# HISTORIC AND DESIGN REVIEW COMMISSION

January 19, 2022

**HDRC CASE NO:** 2022-040  
**ADDRESS:** 725 E WOODLAWN AVE  
**LEGAL DESCRIPTION:** NCB 6203 BLK 4 LOT 19  
**ZONING:** R-4,H  
**CITY COUNCIL DIST.:** 1  
**DISTRICT:** River Road Historic District  
**APPLICANT:** Angel Whitley/Rhino Design Build  
**OWNER:** SAUNDERS REVOCABLE TRUST  
**TYPE OF WORK:** Fenestration and exterior modifications  
**APPLICATION RECEIVED:** December 10, 2021  
**60-DAY REVIEW:** Not applicable due to City Council Emergency Orders  
**CASE MANAGER:** Stephanie Phillips

EAST ELEVATION, HOUSE  
14'1" = 14'0"

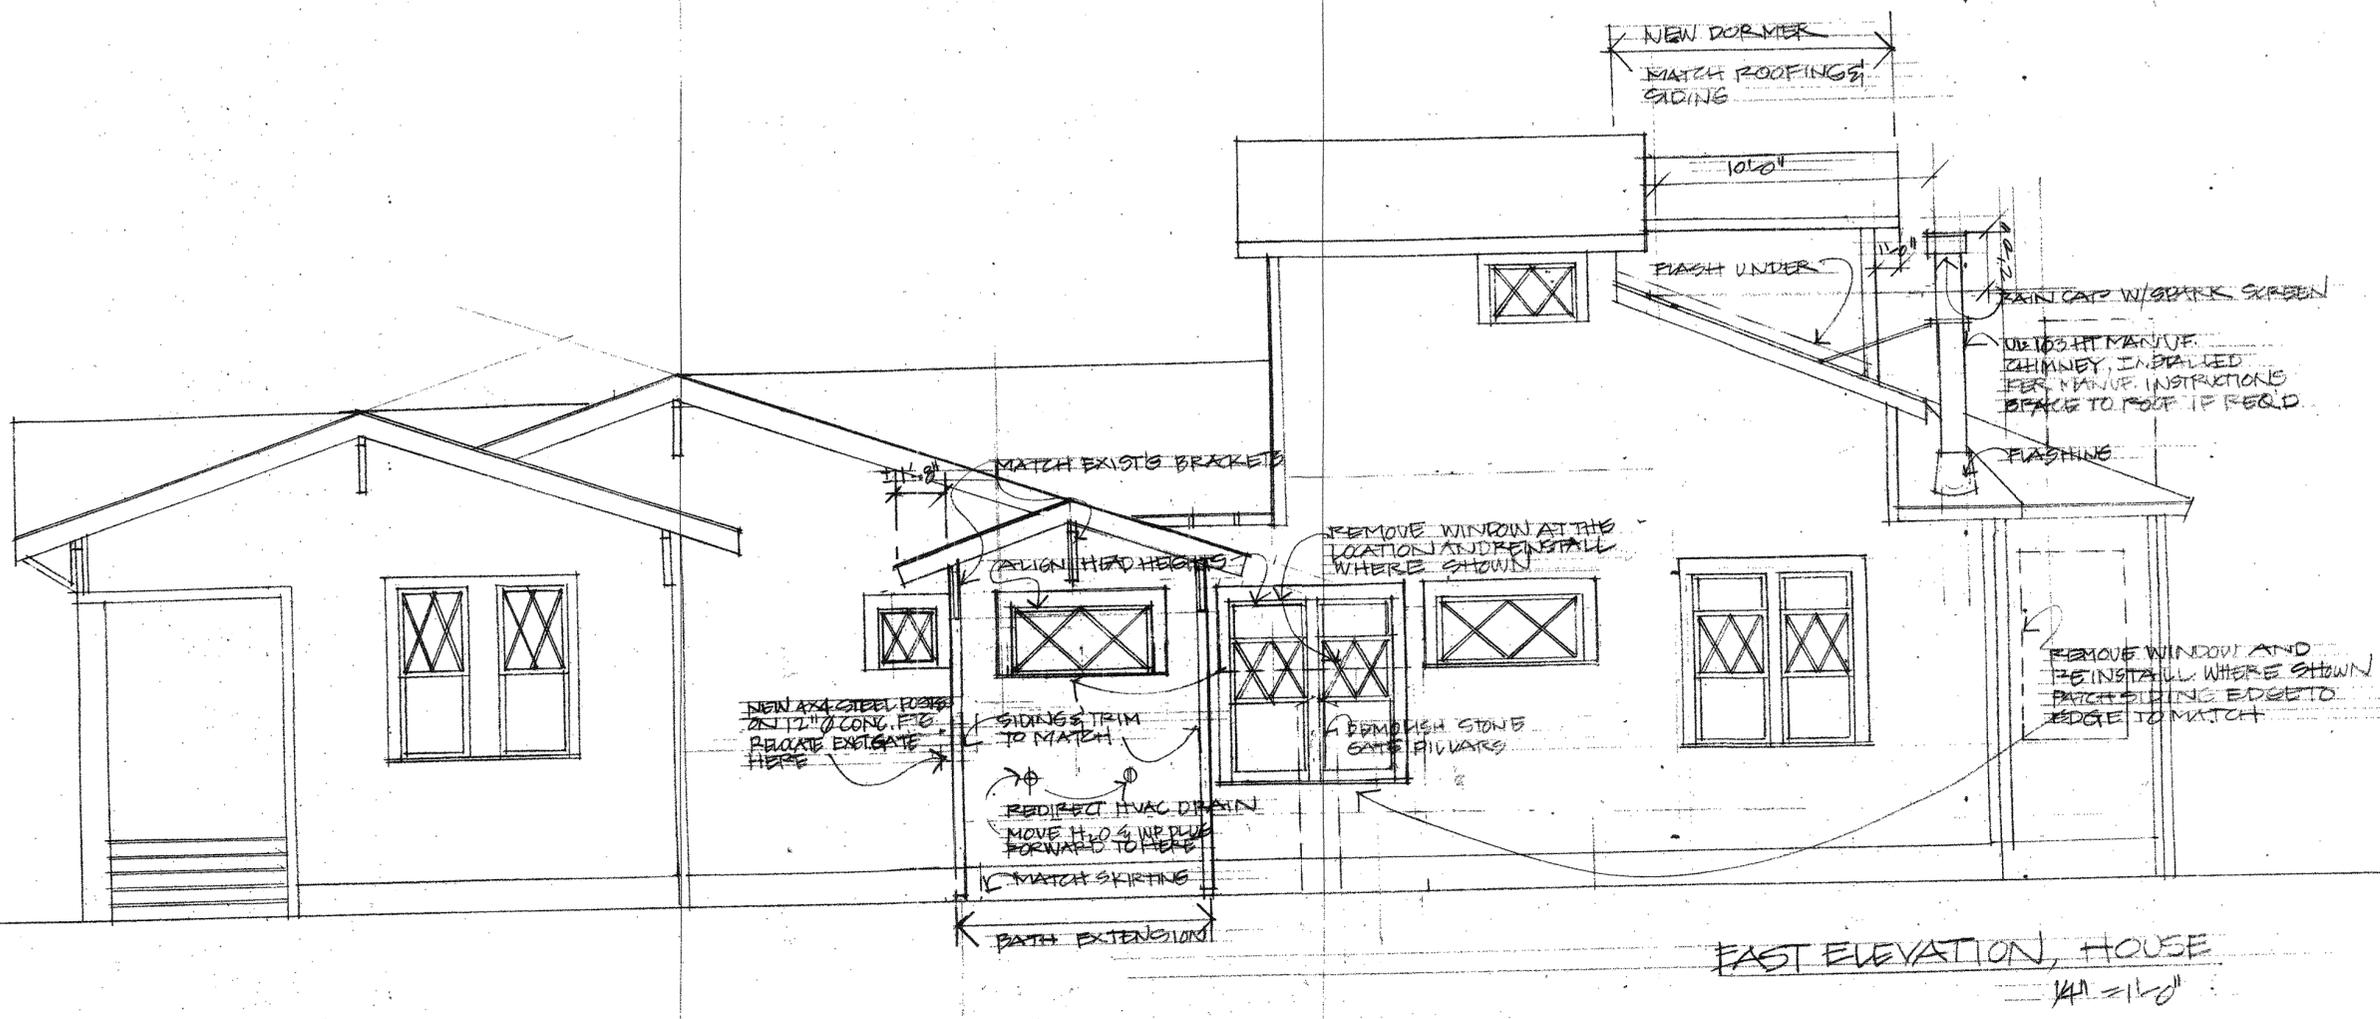
- b. **FENESTRATION MODIFICATIONS: EAST ELEVATION** – The applicant has proposed various modifications to the east elevation fenestration, including relocating a one over one window from the rearmost portion of the elevation to a central area, creating a new ganged window condition; and removing non-original clerestory windows. The window to be relocated is currently located on the rear addition. Per the Guidelines, original window configurations should be preserved. If modifications are proposed, new windows should match the existing windows in terms of size, type, configuration, material, form, appearance, and detail. Staff finds the relocation of a window from the addition to another area of the same elevation, creating a historically compatible ganged trim configuration, appropriate. Staff finds the removal of non-original clerestory windows consistent.

- c. **EAST ELEVATION EXTENSION** – The applicant has proposed to construct a small bump-out addition on the east elevation to accommodate a bathroom extension. The footprint is less than 10 square feet. The footprint will align with the widest point of the east elevation, matching the frontmost mass of the home. An existing horizontal window on the east elevation will be removed and reinstalled on this extension. The material palette will match the existing structure. Staff finds the request consistent with the Guidelines.

Staff recommends approval of the request items based on findings a through f with the following stipulations:

- i. That the applicant submits window specifications for final approval. Windows should be fully wood or aluminum clad wood and feature an inset of two (2) inches within facades and should feature profiles that are found historically within the immediate vicinity. White color is not allowed, and color selection should be presented to staff. Meeting rails must be no taller than 1.25" and stiles no wider than 2.25". There should be a minimum of two inches in depth between the front face of the window trim and the front face of the top window sash. This must be accomplished by recessing the window sufficiently within the opening or with the installation of additional window trim to add thickness. Window trim must feature traditional dimensions and an architecturally appropriate sill detail. Window track components must be painted to match the window trim or be concealed by a wood window screen set within the opening.
